DE-24-087 DOE witness contradicts Eversource testimony.

DOE witness DeVergilio provides no evidence for his statements. He also contradicts statements made by Eversource:

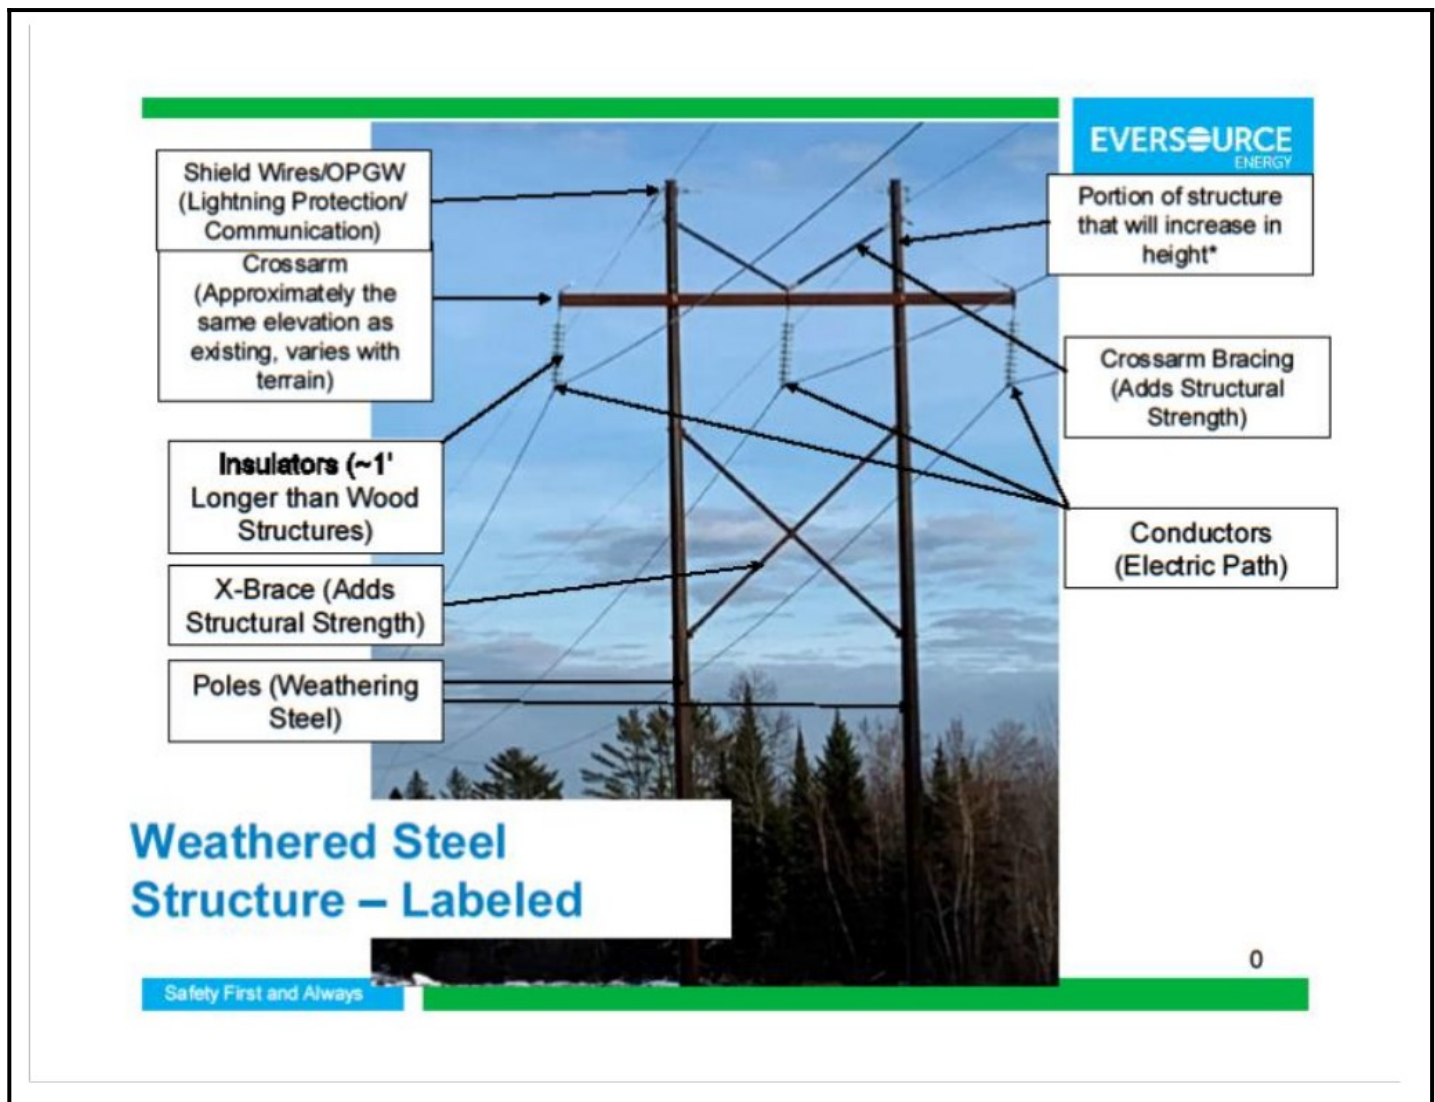
Eversource produced a diagram which shows the structure height increases occurring only above the cross-bar and insulators, and elsewhere claims that the OPGW requires a 15' clearance from the conductors (compared to 10' required by the existing shield wire.)

The diagram does not show structure heights increasing below the cross-bar and insulators because to greater sag of the 1272 conductor:

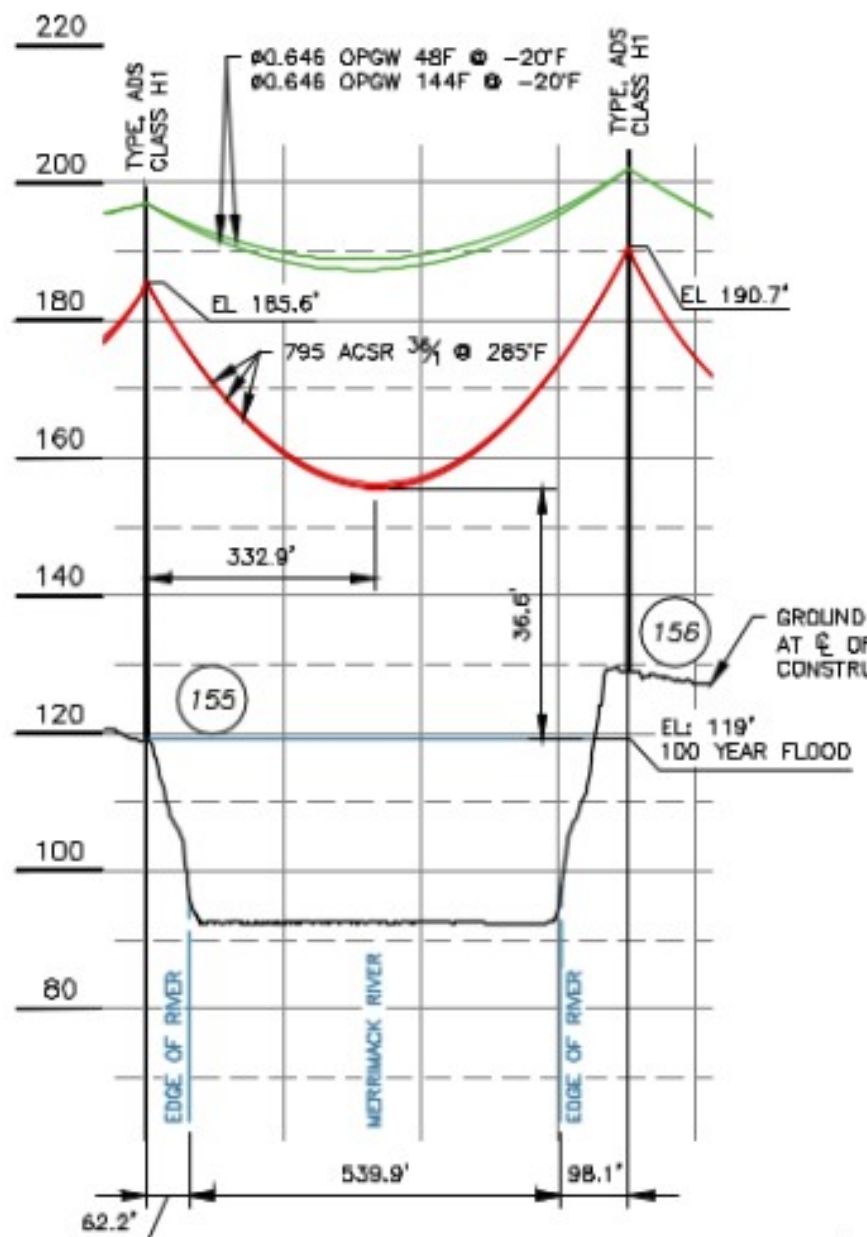
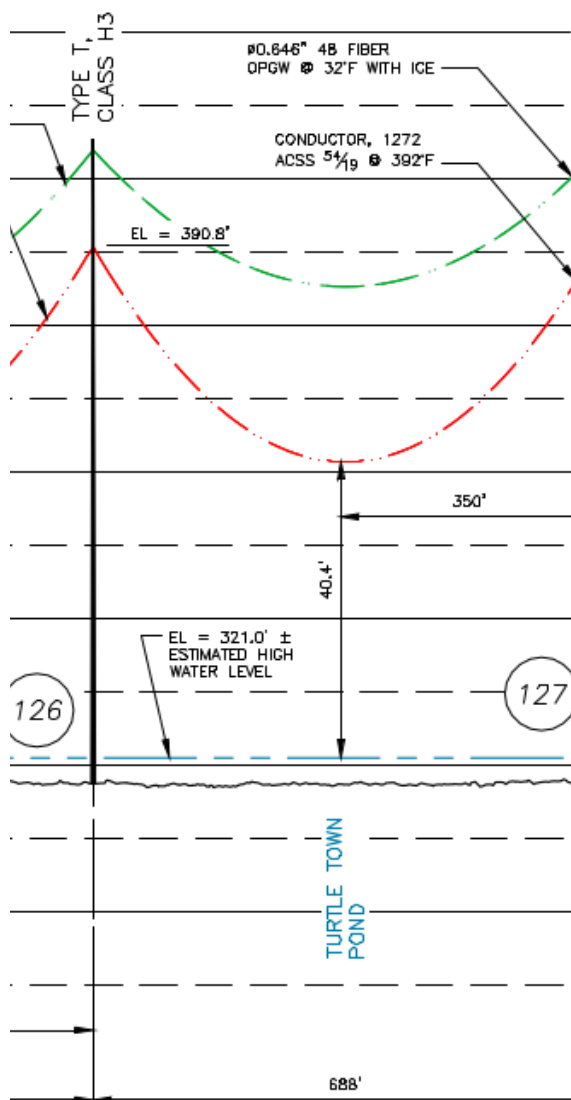
Below, 1272 ACSS
28' sag @ 688' span

Below, 795 ASCR
28' sag @ 700'

The U-199 taps into the X-178 so unless the X-178 was rebuilt with more than doubled capacity, (as Eversource plans) and unless the Woodstock substation and Streeter Pond tap are upgraded to allow this extra capacity to flow to the Z-180 and U-199, which Eversource claims it is not considering, then the U-199 appears to be limited by the X-178 capacity.

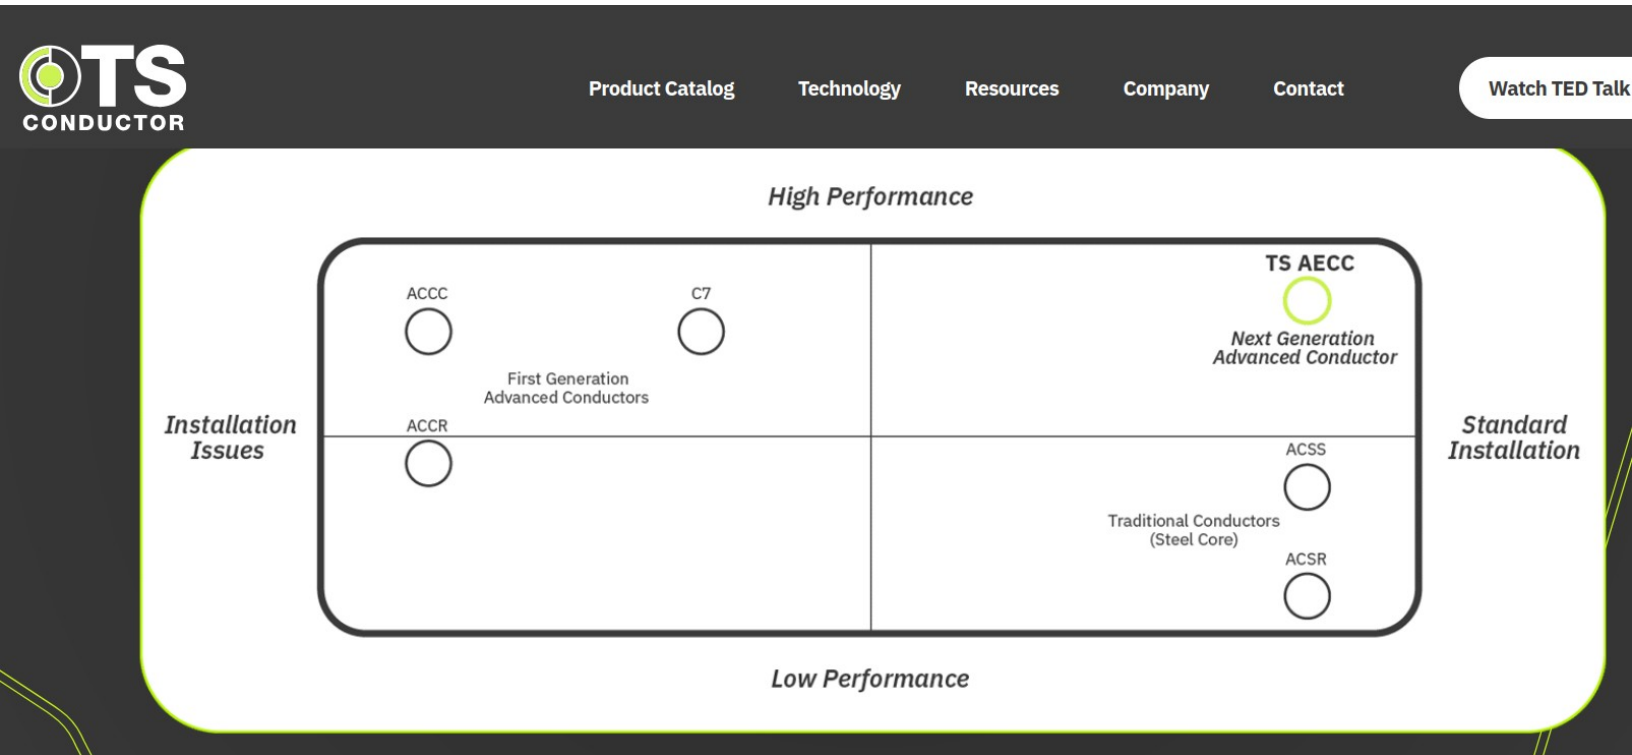
ACSS, Eversource’s standard rebuild conductor, is rated as “Low Performance.”
